Docket Item #1  
BZA CASE #2007-0004

Board of Zoning Appeals  
May 10, 2007

**ADDRESS:** 2719 HEMLOCK AVENUE  
**ZONE:** R-8, RESIDENTIAL  
**APPLICANT:** PAMELA RITCHIE, OWNER

**ISSUE:** Variance to construct a rear dormer addition in the required North and South side yard setbacks.

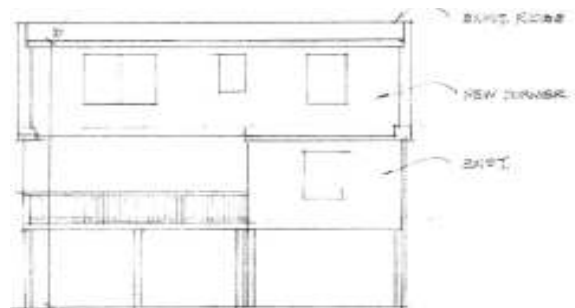
As indicated on the submitted plat, the existing house is located within the required north and south side yard as well as the required front yard. The single-family dwelling is located 24.00 feet from the front property line facing Hemlock Avenue and has two side yards of 5.00 feet.
